LINCOLN CITY/LANCASTER COUNTY PLANNING STAFF REPORT

for JUNE 7, 2006 PLANNING COMMISSION MEETING

PROJECT #: Preliminary Plat #06007, Gale Addition

PROPOSAL: Residential subdivision for 18 single-family lots and 4 attached single-family lots.

UTILITY
PLAN

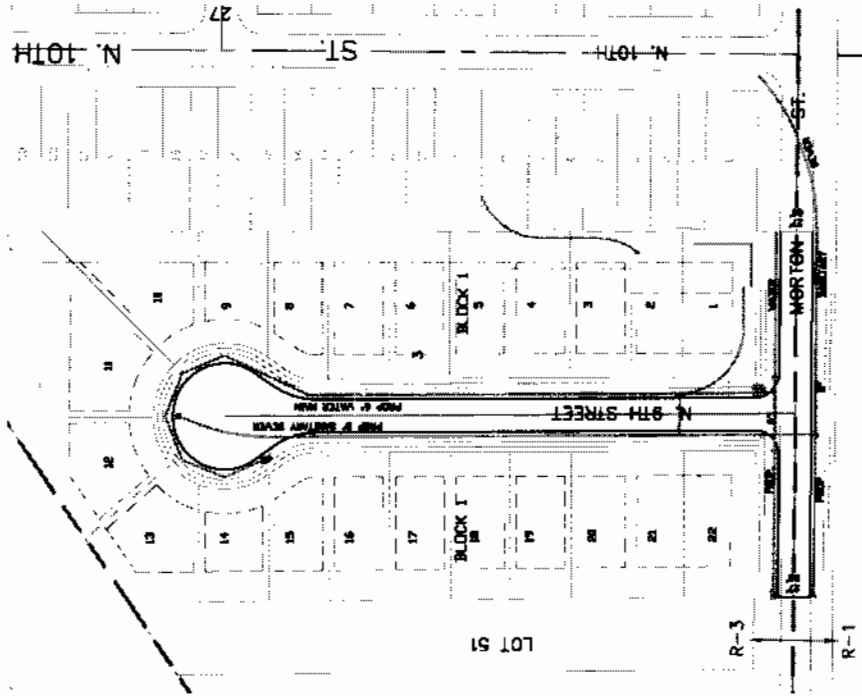
- 1.1.14 Show utility easements as requested by LES memo of May 12, 2006.
- 1.1.15 Revise the site plan showing the detention cell on an outlet.
- 1.1.16 Make corrections to the satisfaction of Public Works and Utilities Department per their memo of May 22, 2006.

(3.2) The 18" storm sewer pipe that the proposed detention cell drains to was sized for the 5 year storm as required by design standards with the Pine Crest development to the east. It is not clear whether the cell was designed to over detain in order to utilize the existing 18" pipe to drain storm events greater than the 5 year storm. Storm routing information needs to be provided showing that the existing 18" pipe is adequate.

LANDSCAPE
PLAN

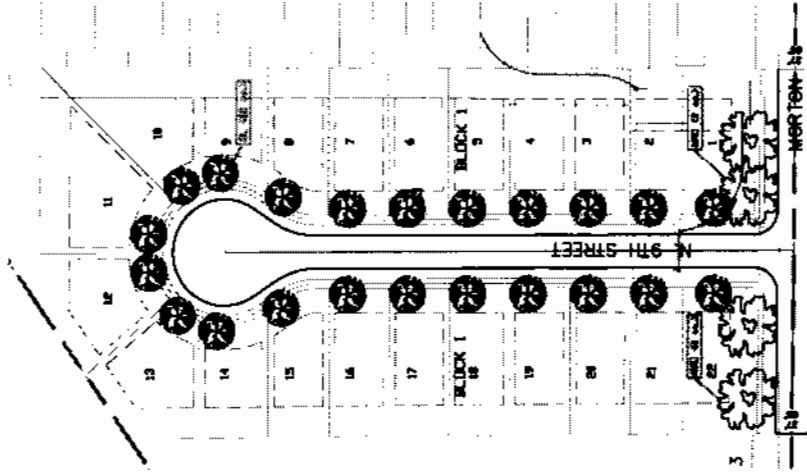
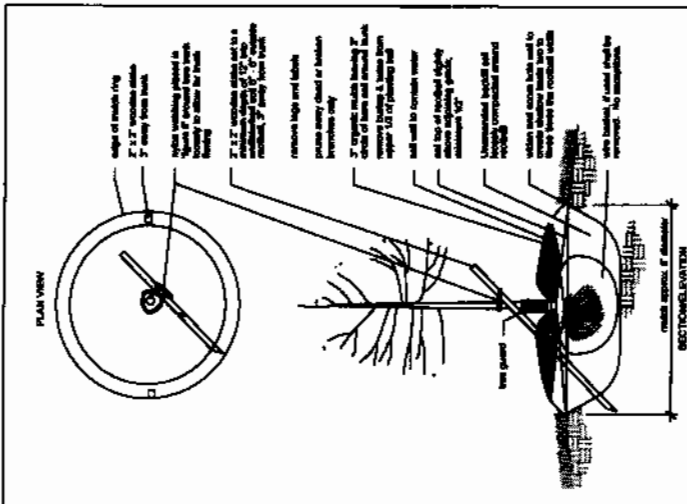
- 1.1.12 Show screening along the rear lot line of Lots 12 and 13.
- 1.1.13 Show the location, size and common name of all existing trees within and adjacent to the subdivision on the landscape plan. Identify which existing trees are scheduled to be removed.

Comments: 1. Contact the Forestry Department at 441-7036 for the assignment of Street Trees.
2. Screening needs to be added along the portion of the property adjacent to I-80.
